SUBJECT: COMANCHE PEAK STEAM ELECTRIC STATION
DOCKET NUMBERS 50-445 AND 50-446
RESPONSE TO QUESTIONS CONCERNING REACTOR VESSEL HEAT-UP
AND COOLDOWN TECHNICAL SPECIFICATIONS

ATTACHMENT A - WESTINGHOUSE RESPONSE TO NRC COMMENTS ON COMANCHE PEAK
UNITS 1 AND 2

FIGURE B-1 Uniform Bending Moment M_0 Applied to a Long Cylinder
(Positive Direction as Shown)

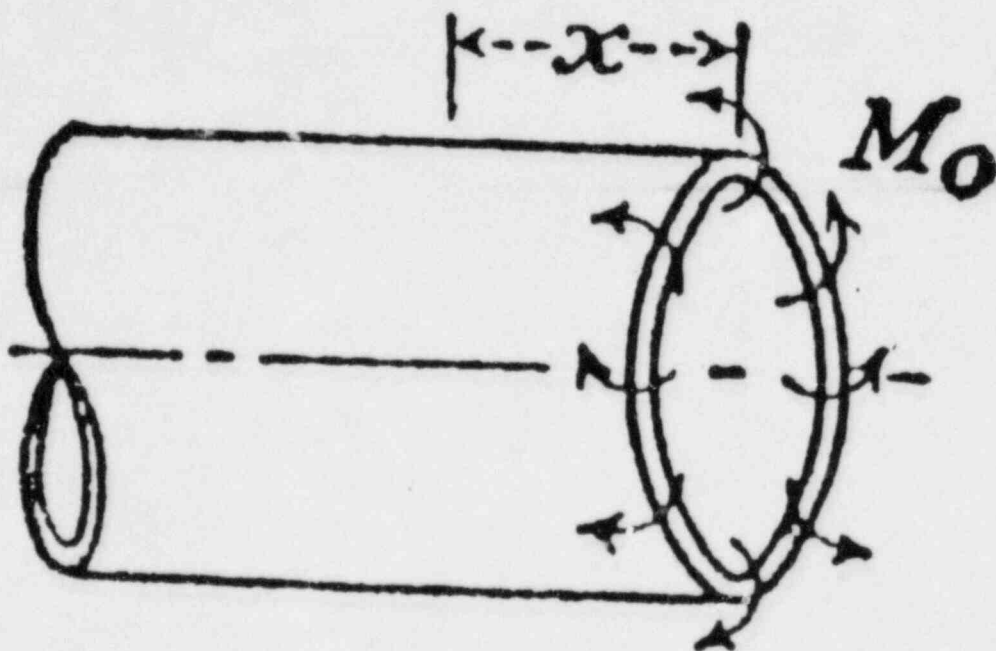
This appendix contains the methods contained in Roark, Case 15, page 302 4th Edition.^[B-1] This analysis determines the effect of a uniform radial moment at the end of a long cylinder. Consider the cylinder shown by Figure B-1 imposed with a radial moment M_0 of -538.8 in-kips/in. from Table 1. Determine the effect of this moment at distance x from M_0 along the cylinder. The bending stress at distance x (σ_x) is given by the following equation:

$$\sigma_x = \pm \frac{6M_0}{t^2} e^{-\lambda x} (\cos \lambda x + \sin \lambda x) = \pm 13.05 \text{ ksi} \quad (\text{B-1})$$

t = critical cross section thickness shown in Figure B-2 = 10.75 in.

x = distance from M_0 to the vessel flange to shell juncture shown in Figure B-2 = 26.00 in.
